SUBJECT: TECHNICAL SPECIFICATION CHANGES RELATING TO THE CYCLE 9
RELOAD FOR DRESDEN NUCLEAR POWER STATION, UNIT NO. 3

AMENDMENT TO FACILITY OPERATING LICENSE

Amendment No. 74
License No. DPR-25

SAFETY EVALUATION BY THE OFFICE OF NUCLEAR REACTOR REGULATION
SUPPORTING AMENDMENT NO. 74 TO FACILITY OPERATING LICENSE NO. DPR-25
COMMONWEALTH EDISON COMPANY
DRESDEN NUCLEAR POWER STATION, UNIT NO.3
DOCKET NO. 50-249

Figure 3.5-2 (Sheet 1 of 2) MCPR Limit For Reduced Core Flow

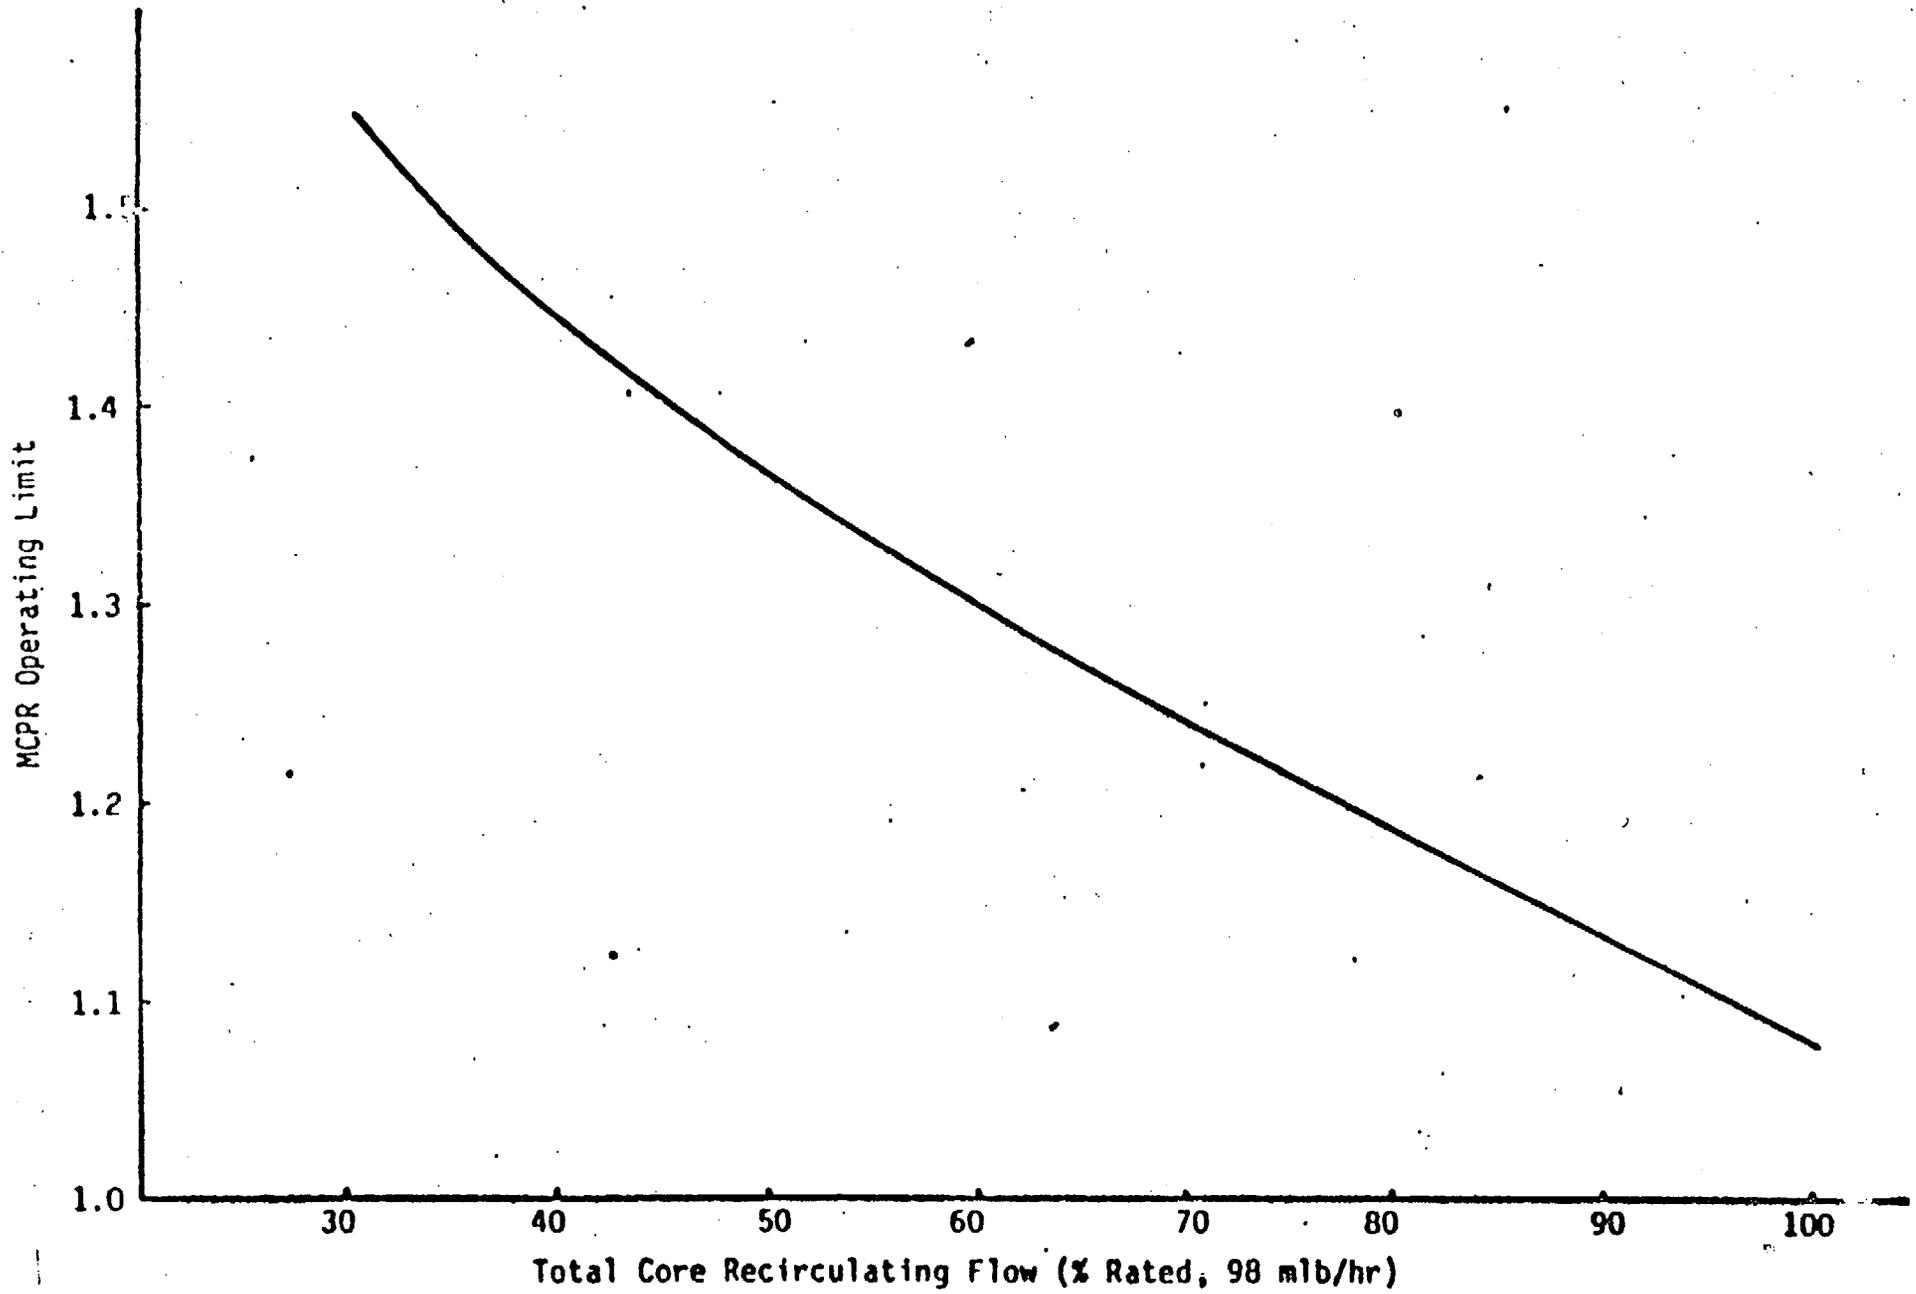
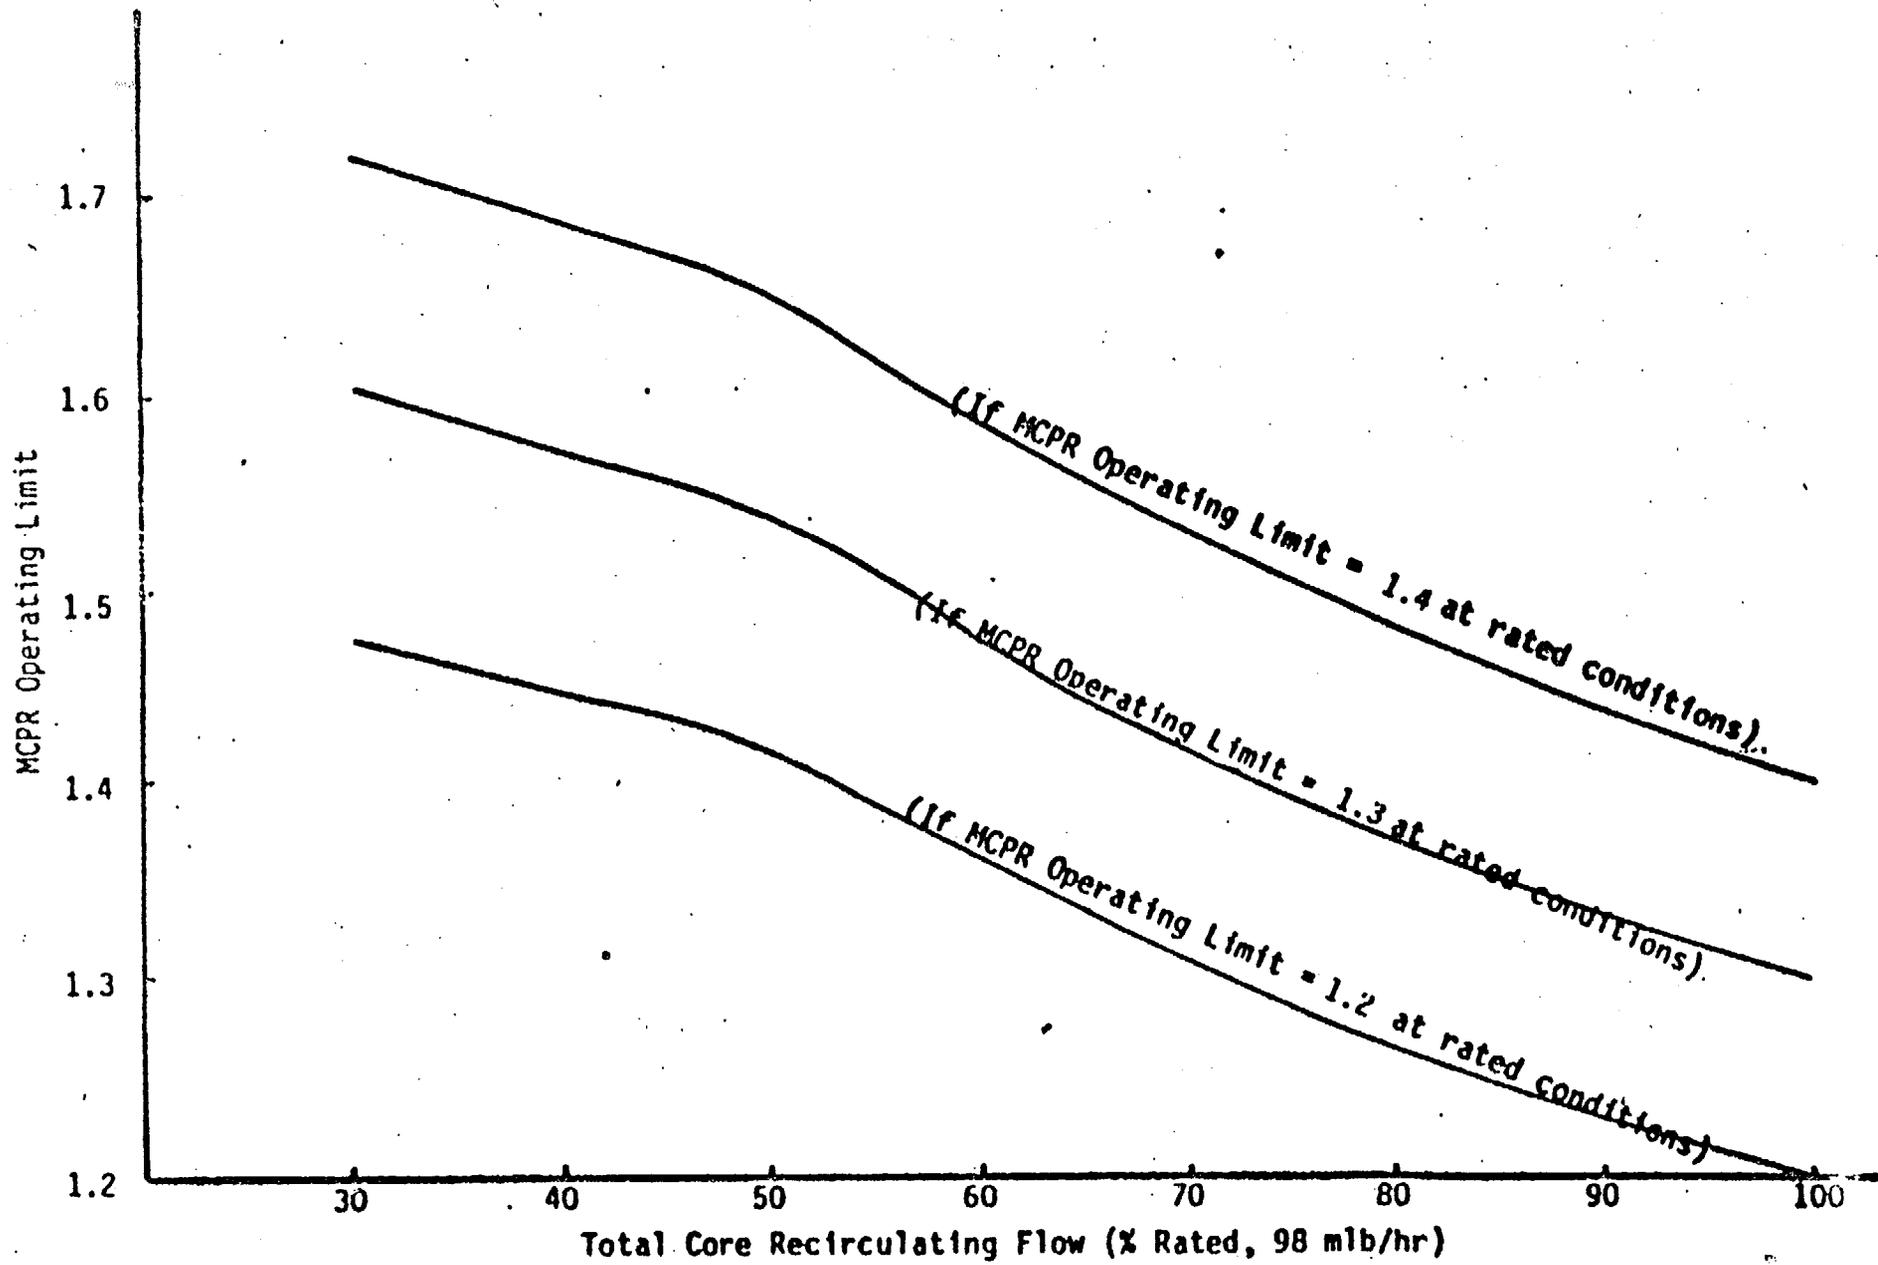
1. Manual Flow Control - the MCPR Operating Limit shall be the value from Figure 3.5-2 sheet 1 or the above rated flow value, whichever is greater.
2. Automatic Flow Control - the MCPR Operating Limit shall be the value from Figure 3.5-2 sheet 1, sheet 2, or the above rated flow value, whichever is greatest.

The licensee has submitted proposed Technical Specifications for D3C9 operation (Ref. 6). Section 3.5.K specifies the operating limit MCPRs, which are 1.33 for the ENC and GE 8x8 fuel designs and 1.34 for GE 8x8R fuel when scram times are less than or equal to 2.58 seconds. When the measured scram time becomes greater than 2.58 seconds the OLMCPR must be increased using the equation specified in Appendix A to XN-NF-83-47. Both the OLMCPR limit and the equation for adjusting the OLMCPR are currently in the Dresden 3 Technical Specifications. The only change to Technical Specification 3.4.K is to revise Figure 3.5-2 to incorporate the ENC curves for determining the OLMCPR for core flows less than rated flow. The revised Figure 3.5-2 is determined using the ENC methods documented in XN-NF-81-84, which is still under review by the staff. However, the review has progressed to the point where the staff concluded that the ENC methodology and the calculated results are acceptable for the D3C9 reload. The staff, therefore, has concluded that the revised Figure 3.5-2 is acceptable.

The staff has reviewed the thermal-hydraulic design for the D3C9 reload core and has found that the results of analyses (XN-NF-83-47) support the proposed operating limit MCPRs, which avoid violation of the safety limit MCPR for design transients. The staff, therefore, concludes that this core reload will not adversely affect the capability to operate Dresden 3 safely during Cycle 9 operation and the proposed Technical Specification 3.5.K and the revised Figure 3.5-2 of the Technical Specifications discussed above are acceptable.
